Last saved	18/05/2016 13:54
Path	RMam-12336-27-180516-35 27A Parkway-F1.doc
Author	Robert Morley MEng
Project Partner	E M Brown, BSc MSc CGeol FGS
Project Number	12336-27
Project Name	27A Parkway, London NW1 7PN
Planning Reference	2015/2976/P

# ElliottWood Responses to Appendix 2 (A2) Basement Impact Assessment Audit Queries

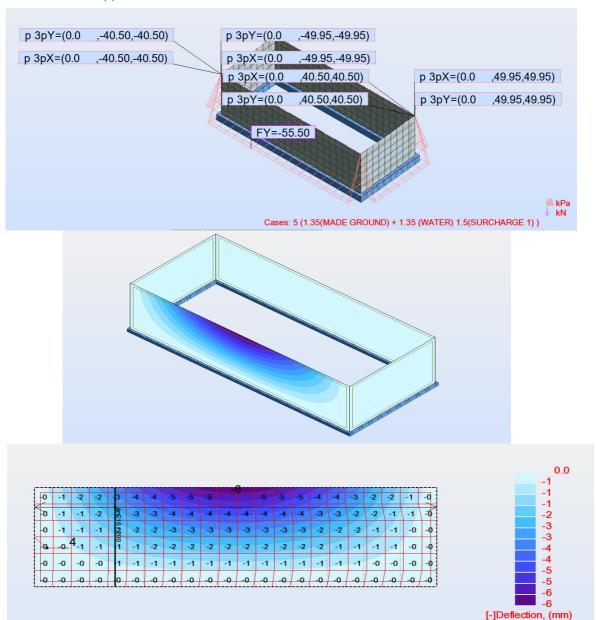
The ground movement assessment has used values for high stiffness walls for the calculation of vertical and horizontal ground movements due to wall deflection. However this is not considered appropriate given that the proposal consists of an unpropped cantilever wall which CIRIA 580 describes as a low stiffness scenario. This should include a damage assessment of the highway(Arlington Road) also.

With regard to the stiffness of the long-term propping system, and the ground movements predicted by the CIRIA C580 data we will need the view of the structural engineer; if the structure is likely to limit the horizontal movement of the top of the front and rear retaining walls, at the mid-point of their long sides, to less than 6mm following removal of the temporary strutting then we can consider the wall to be stiffly propped. If greater than 6mm of horizontal deflection is likely then the effects of less-stiff propping will need to be considered.

If the horizontal movement of the top of the wall is likely to be of the order of 12mm, then this corresponds to the behaviour of low-stiffness support. Under these conditions up to 16mm of vertical ground settlement can be expected outside the excavation, rather than the currently predicted 4mm. Overall tilt of nearby walls will be predicted to approach the 1:400 limit requiring remedial action and the predicted damage due to distortion will be 'slight' at best.

We have considered the GMA team's comments and completed an analysis to calculate expected deflections based on the current thickness of our wall and also determine the steel reinforcement that would be required to limit horizontal movement at the top of the wall.

As we expected; despite the basement being "open topped", the stiffness of the raft and the return walls help to keep deflections within acceptable limits. See a screenshot below of the FE model which shows the deflection of the wall adjacent to Arlington Road.

The analysis appears to show a maximum horizontal deflection of the order of 5-6mm for the front wall of the basement under adverse temporary conditions. For the damage category assessment it would be expected that only normal long-term loads (earth pressure loads) would be considered (the CIRIA movement profiles on which the damage category assessments are based are themselves based upon a conservative interpretation of case-history data, and it is unlikely that flood conditions or adjacent traffic loads would have been present) therefore the engineer's analysis below can be considered conservative, probably highly so.

Therefore we consider that the displacements indicated are consistent with predictions made on the basis of an assumption of stiffly propped basement walls, as adopted in the existing DCA report.
